Green Hill Solar Farm

EN010170

The Applicants Response to Written Representations at Deadline 3

Document Reference: EX4/GH8.1.28

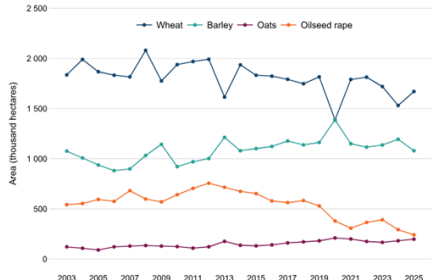
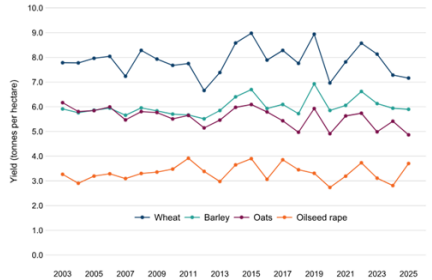
CPRE-015	Agriculture and Soils	Potential Release of Sequestered Carbon and loss of biodiversity	The government's "Land Use Consultation" was roundly criticised for its lack of rigour and thankfully seems to have disappeared without trace. The expectation expressed that	The Government's responses to the Land Use Consultation are not yet published, and so cannot be commented upon.

Reference <i>(when referring to [REP2-048] the reference numbers have remained consistent)</i>	Theme	Issue	Comments/Issue Raised	Applicants Response
			<p>improvements in agricultural productivity would offset land loss was particularly challenged because productivity is reducing because of environmental measures such as the use of fewer inputs such as fertilizer and crop sprays and the impacts of climate change. Last year the UK had the worst harvest for many years which should be taken as a warning that should be heeded.</p> <p>If the replacement cereal is to be grown in the UK it is inevitable that additional land will have to be converted to intensive agriculture.</p>	<p>There are many factors influencing the UK's cereal production. Defra's statistical publication Cereal and Oilseed Production in the UK 2025, updated 12 December 2025, records that in 2025 wheat production was up 7.3% on 2024, barley was down about 10%, and oats were down 2.3%. Defra's statistical publication Agricultural Land Use in the UK 2025, updated 17 December 2025, recorded the area of uncropped arable land at 576,000 hectares, approximately 12% of arable land. Climatic factors such as the weather, the area and type of crop planted influenced by world prices and factors such as disease risk, and the influence of Government policies such as payments for agri-environmental, non-food uses, all influence the area and yield of the crops grown in the UK.</p> <p><i>Insert from Cereals and oilseed production in the UK 2025</i></p>

Reference <i>(when referring to [REP2-048] the reference numbers have remained consistent)</i>	Theme	Issue	Comments/Issue Raised	Applicants Response
				<p>Figure 1: United Kingdom crop areas between 2003 and 2025</p>  <p>Yields were generally down from 2024 for a number of factors including the weather.</p> <p>Figure 2: United Kingdom crop yields between 2003 and 2025</p>  <p>The graphs show that yields and overall production varies year to year. As noted, about 12% of arable land is not currently in production. The influence of solar development on the overall production is minimal. It is not inevitable that additional land will have to be converted</p>
